Clarifying EPD and LPD

Document ID: maint-Marks-Finn-hlpde-1119-copyright

Re: 802.1 Maintenance, related to IEEE Std 802-2014, IEEE Std 802.1AC-2016, and IEEE Std 802.1Q-2018

This document addresses inconsistencies in the description of EtherType protocol discrimination (EPD) between IEEE Std 802-2014, IEEE Std 802.1AC-2016, and IEEE Std 802.1Q-2018.

Figure 6—LLC sublayer in 802 RM

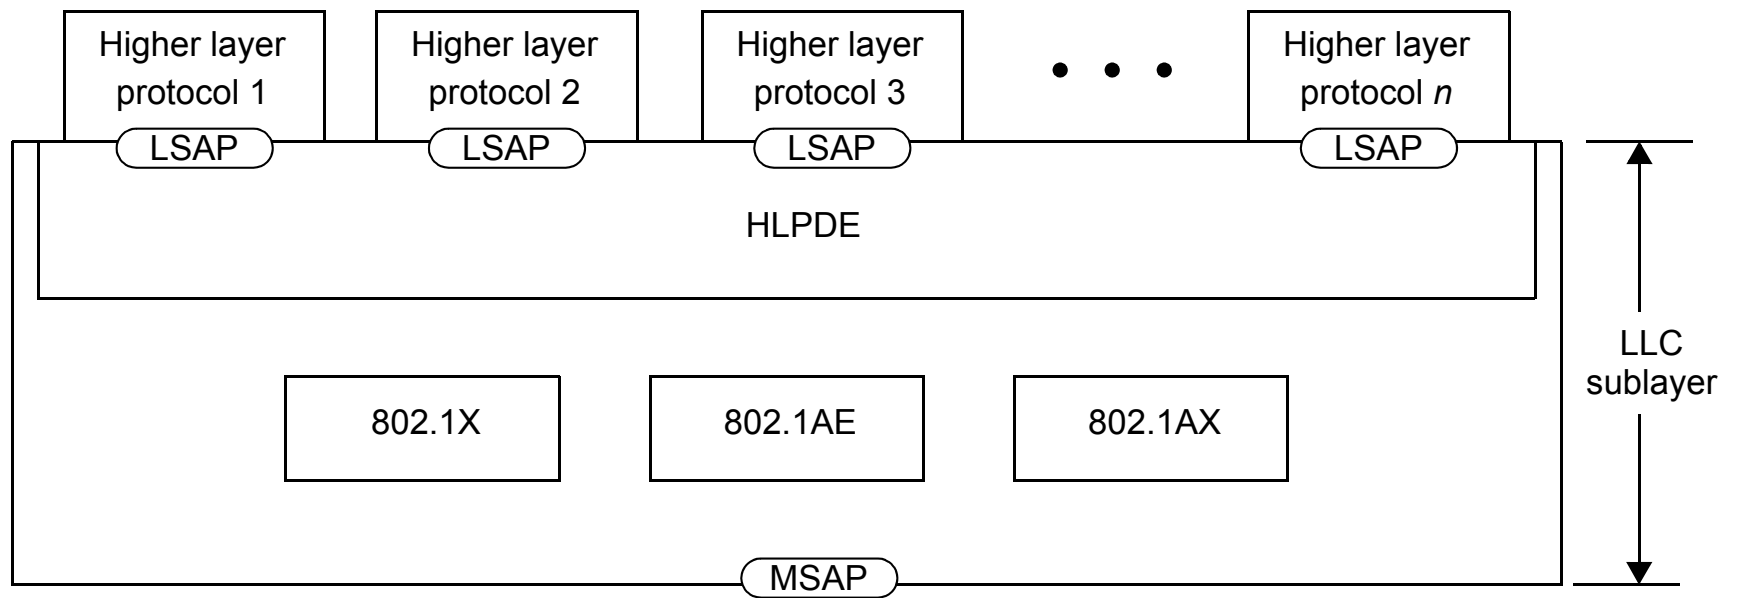
HLPDE in IEEE Std 802

In IEEE Std 802 (subclause 5.2.2), HLPDE is described generally, as part of the LLC, but not specified:
